Thursday, April 11, 2024

## SUBDIVISION AUTHORITY AGENDA MEETING NO. 15

Subdivision Authority

LDA23-0039

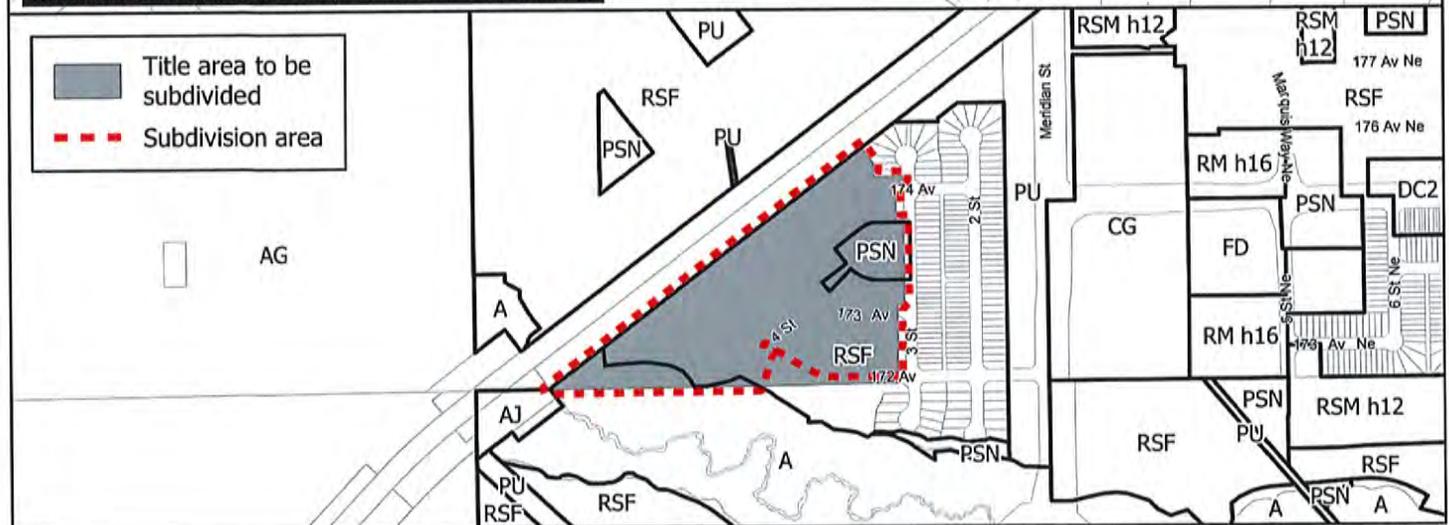
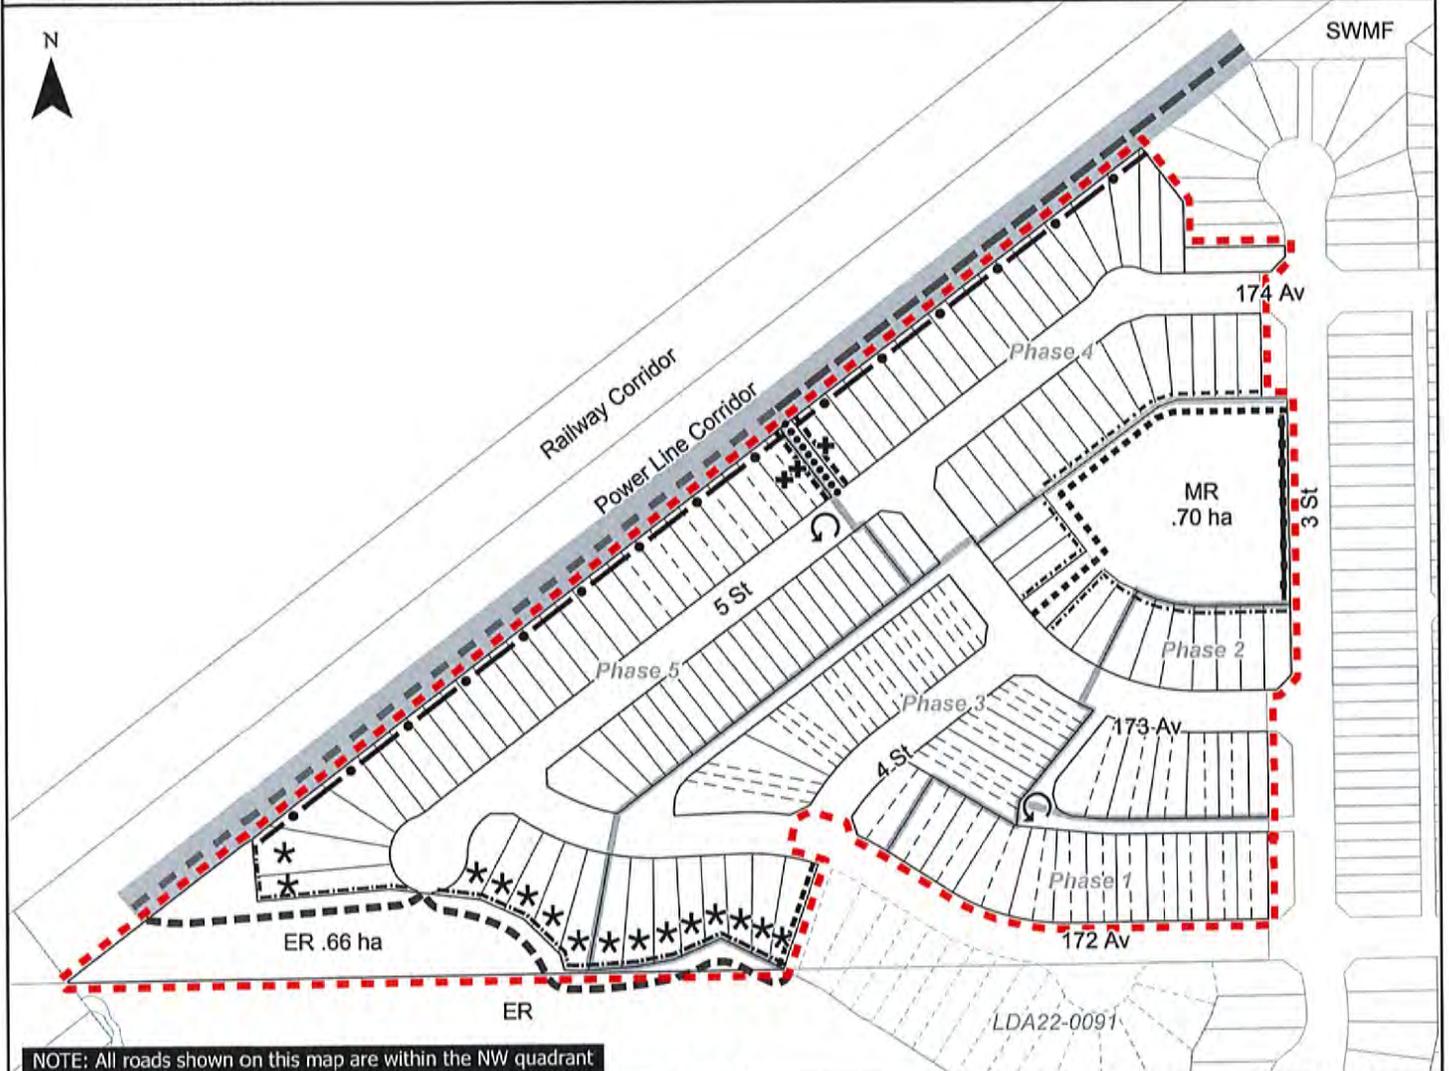
The subdivision was initially approved on April 11, 2023. This change request adds 21 residential lots and revises phasing.

7. that the owner be permitted to register this plan of subdivision in phases in sequential order, as shown on the "Conditions of Approval" map, Enclosure I;

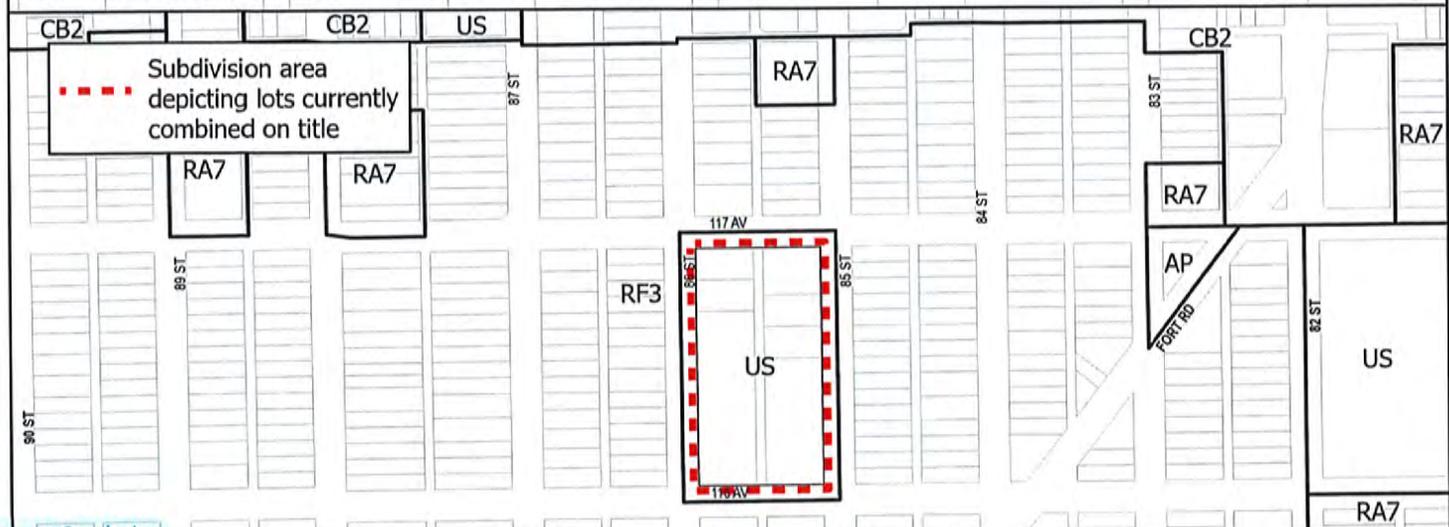
The subdivision was originally approved on November 9, 2023. This Change Request proposes to remove the proposed MR designation off of Lot 1 and change its designation to "other."

2. that the owner pay all costs specified in the Servicing Agreement prior to endorsement of the plan of survey;
3. that the owner construct a concrete sidewalk within the proposed Lot 1, south of 117 Avenue NW from 86 Street NW to 85 Street NW, to the satisfaction of Subdivision and Development Coordination, as shown on the "Conditions of Approval" map, Enclosure I. The details of this requirement will be reviewed and finalised through an engineering drawing review and approval process;

**April 11, 2024 LDA24-0026**

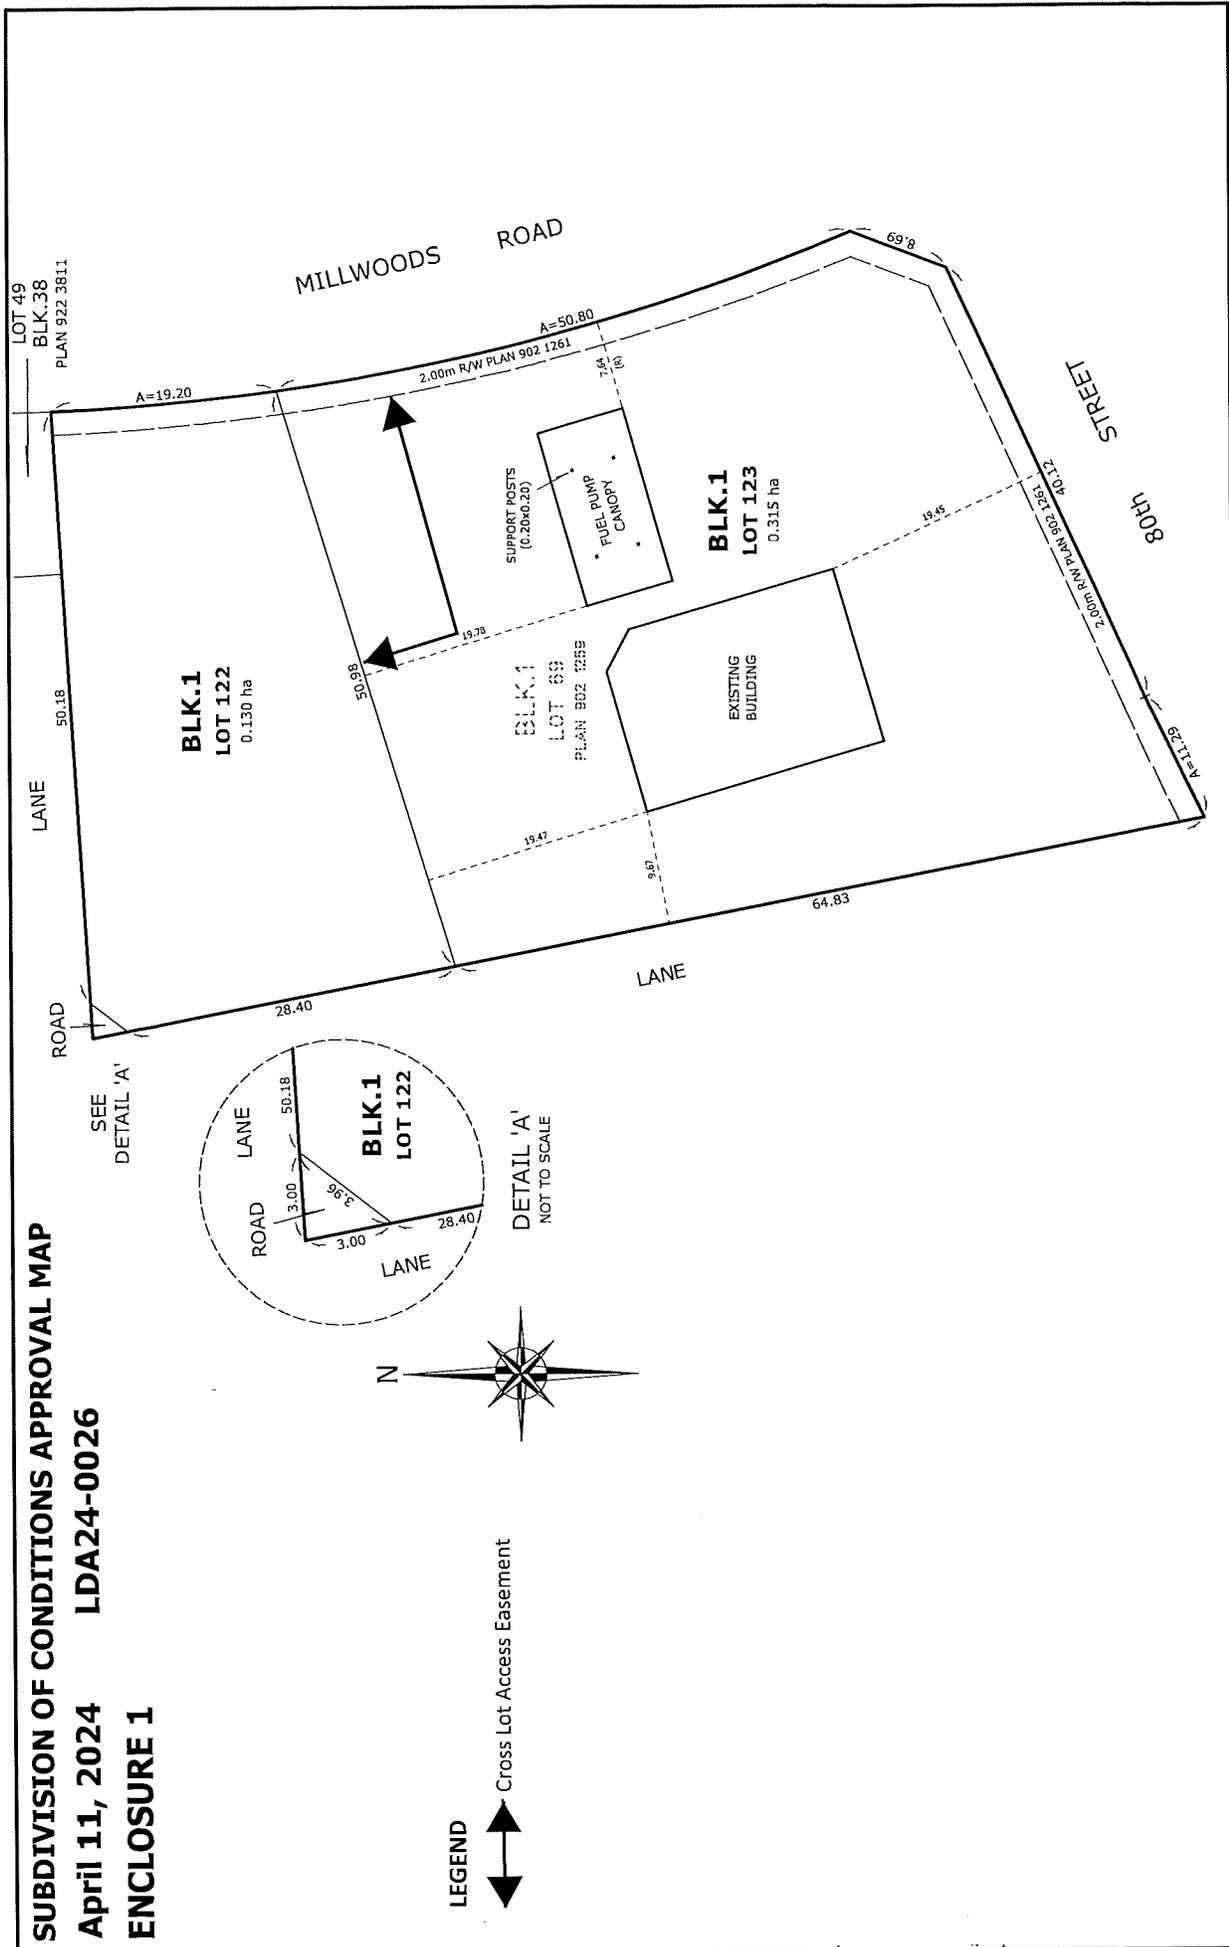
The application was originally approved on March 13, 2024. This first Change Request removes the servicing agreement condition, as it was determined that water, sanitary and storm could be provided off of Mill Woods Road. The Change Request also shifts the proposed subdivision line 3m to the north.

## TENTATIVE PLAN SHOWING PROPOSED SUBDIVISION

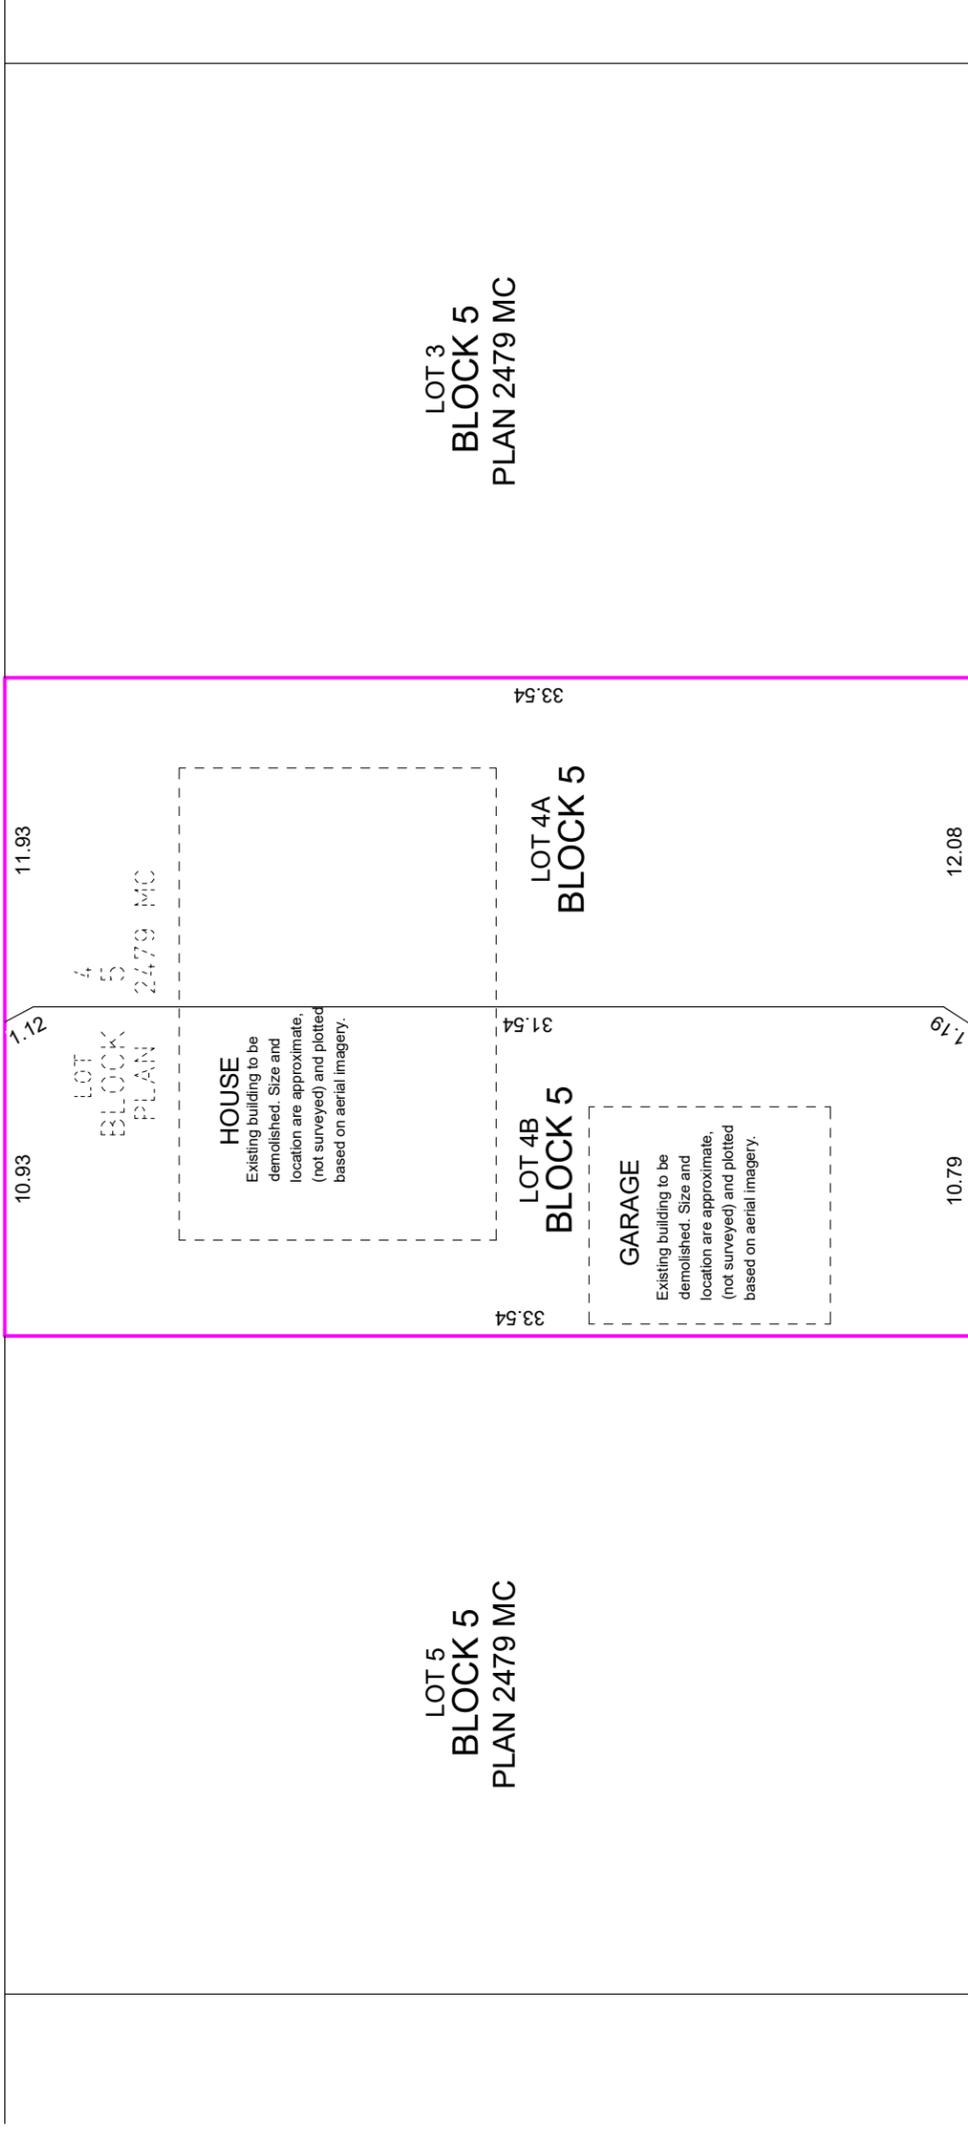
1. that the final plan of survey shall conform to the attached revised tentative plan; and
2. that the owner pay all outstanding property taxes prior to the endorsement of the plan of survey.

- The existing services (water and storm) enter the proposed subdivision approximately 11.43 m east of the west property line of Lot 4 off 53 Avenue NW. The existing sanitary service enters the proposed subdivision approximately 11.58 m west of the east property line of Lot 4 off the lane. As per the EPCOR Drainage Services Bylaw and the EPCOR Water Services and Wastewater Treatment Bylaw, these services cannot cross the proposed property line.

**TENTATIVE PLAN**  
 Showing Proposed  
 SUBDIVISION

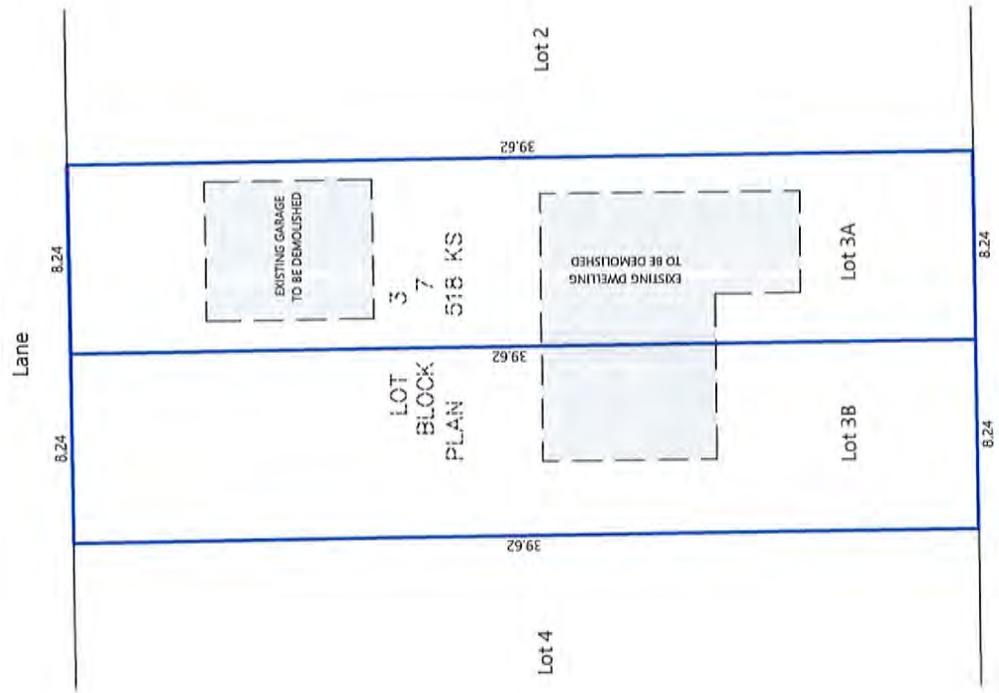
- The existing services (water and sanitary) enter the proposed subdivision approximately 2.4 m west of the east property line of Lot 3A off the lane. As per the EPCOR Drainage Services Bylaw and the EPCOR Water Services and Wastewater Treatment Bylaw, these services cannot cross the proposed property line.

- There is an existing power pole and guy wire that may interfere with access to the proposed Lot 3B. Subdivision Planning recommends that the applicant/owner contact EPCOR Distribution & Transmission to confirm whether this pole will inhibit alley access to the site, which may result in a delay with the issuance of the Development Permit. Contact EPCOR Customer Engineering Services for more information ([ces@epcor.com](mailto:ces@epcor.com) or 780-412-3128).
